REQUEST FOR TECHNICAL REVISION (TR) COVER SHEET

Asphalt Paving Co., Ralston Quarry M-1974-086
Technical Revision – Modifications to Slide Repair Designs and Plans

**Limited Geotechnical Evaluation
Slope Stability and Remediation Approach
Ralston Quarry
Jefferson County, Colorado
Revised6**

Ma C-4 Storage Water Detention
Rational
Avalanche Protection Co.

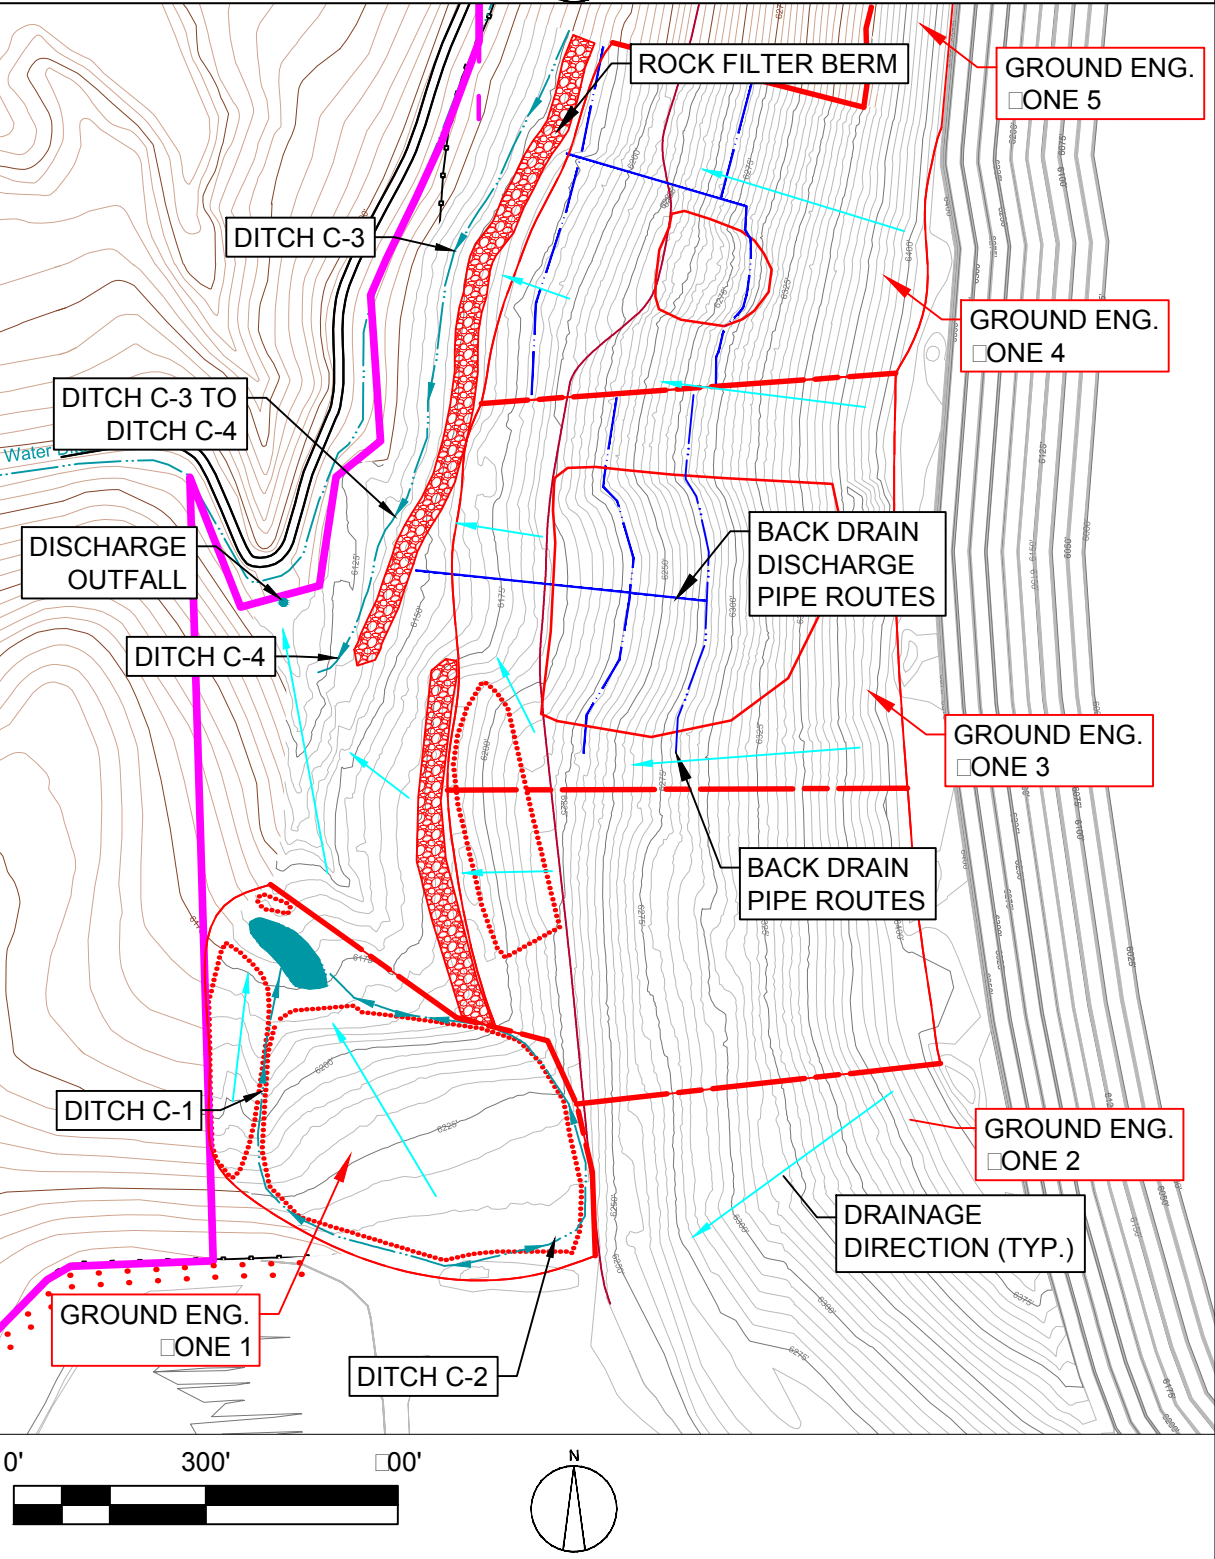
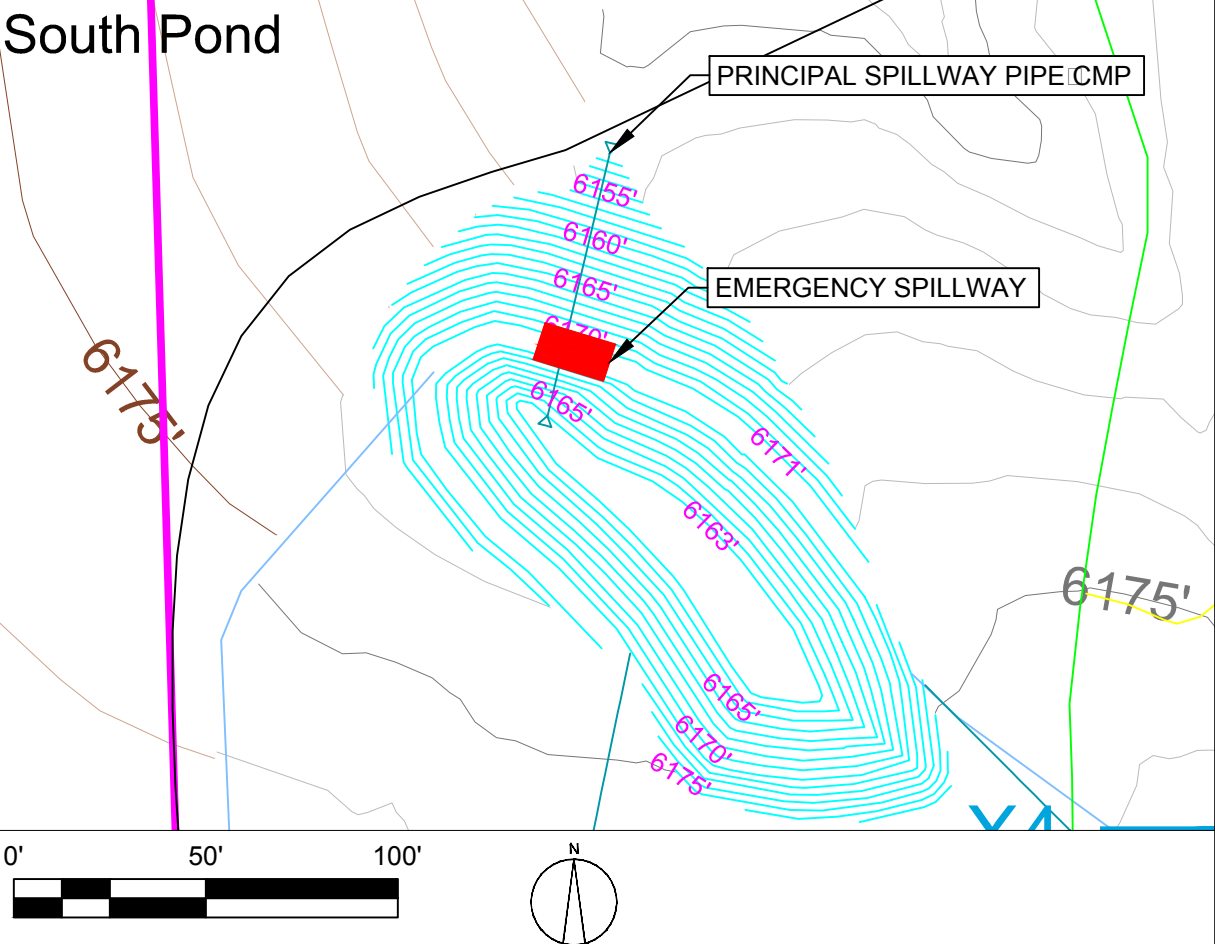
Map C-4 and F-2 show the revised subsurface pipe locations. None of the stormwater designs on Map C-4 have been changed from the approved permit designs.

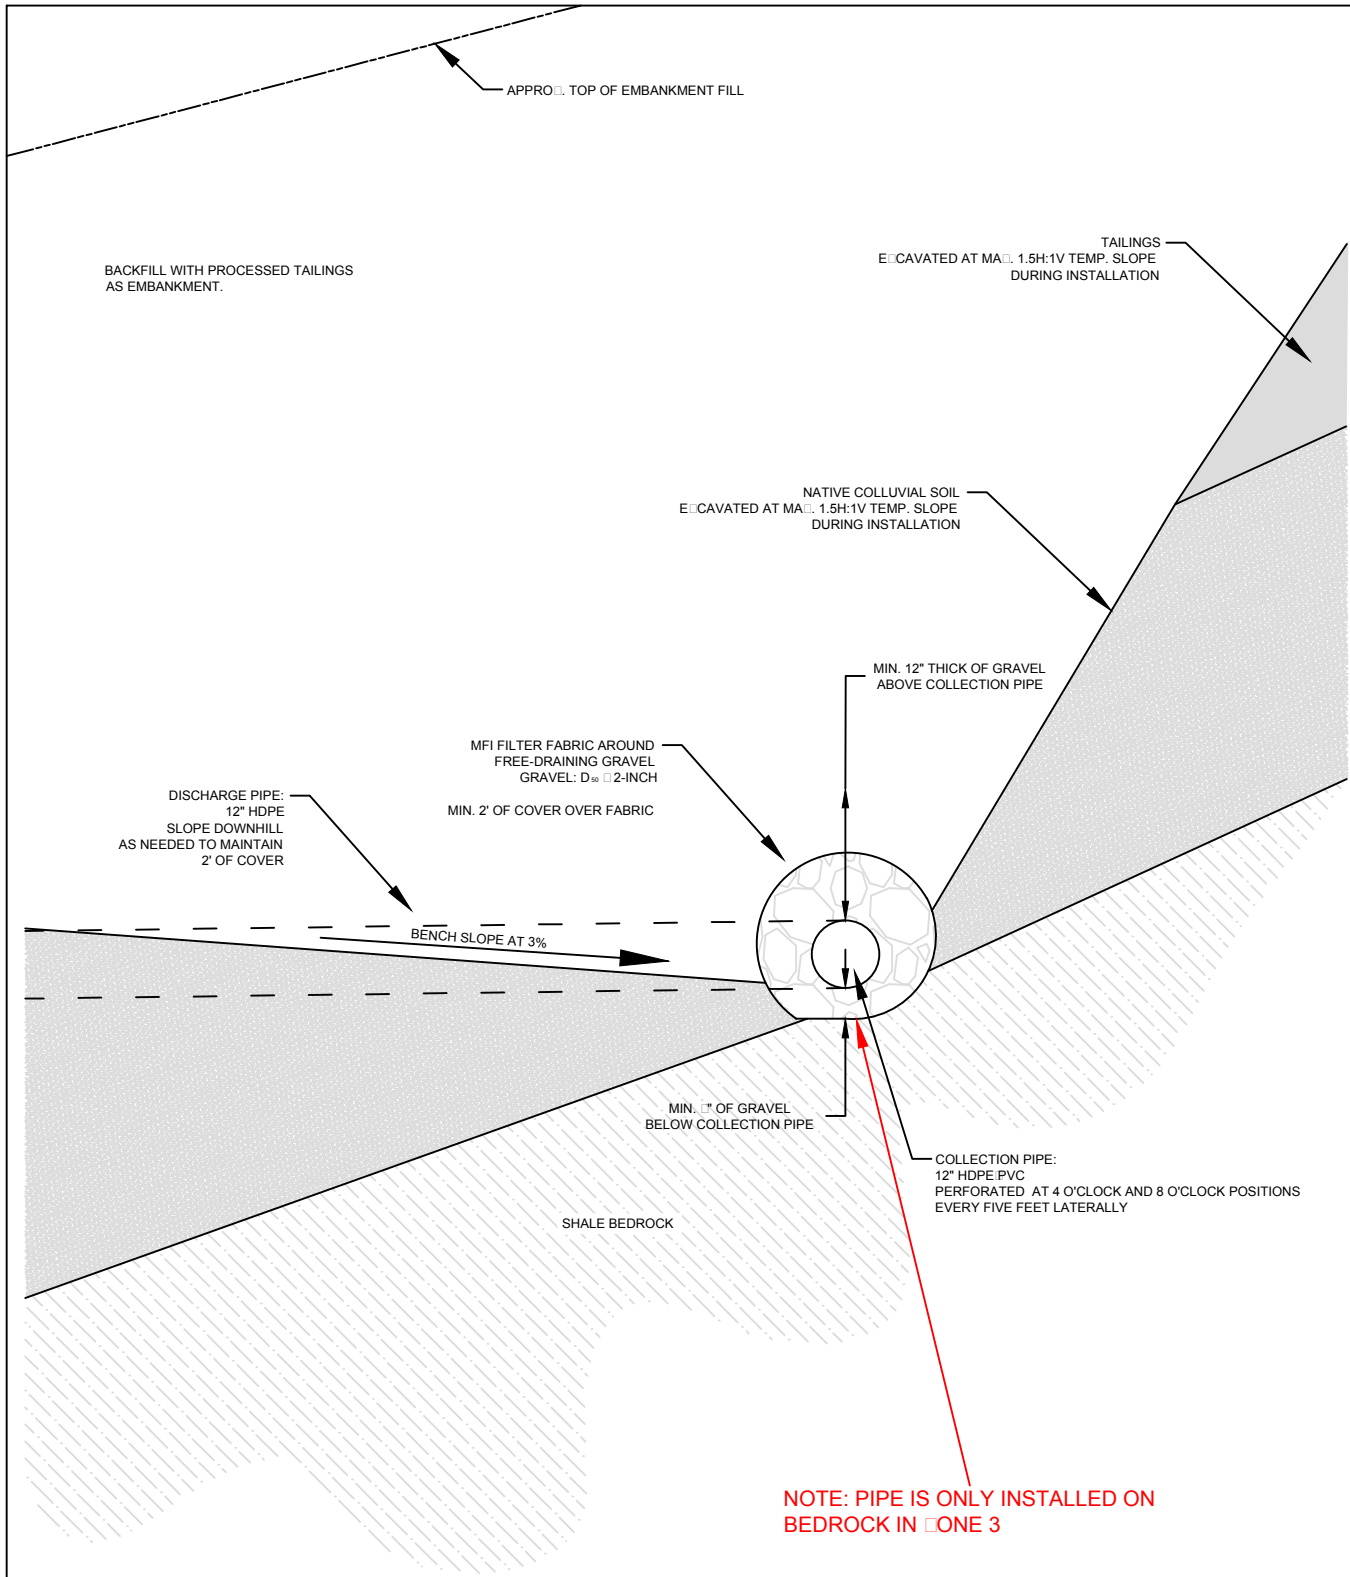
All subsurface drainage systems will consist of a minimum of 12-inch diameter pipe installed as shown on Map C-5. This pipe size was determined using the design standards from the Natural Resource Conservation Service Part NJ650.14¹ applied to a smooth HDPE pipe. The drainage area is ~17 acres. Inflow pipes (transverse to surface grade) will be perforated while transport pipes (longitudinal to surface grade) will be solid to convey drainage water to the slope toe. Additionally, this pipe size is in excess of Ground Engineering's recommendations for pipe size and flow capacity.
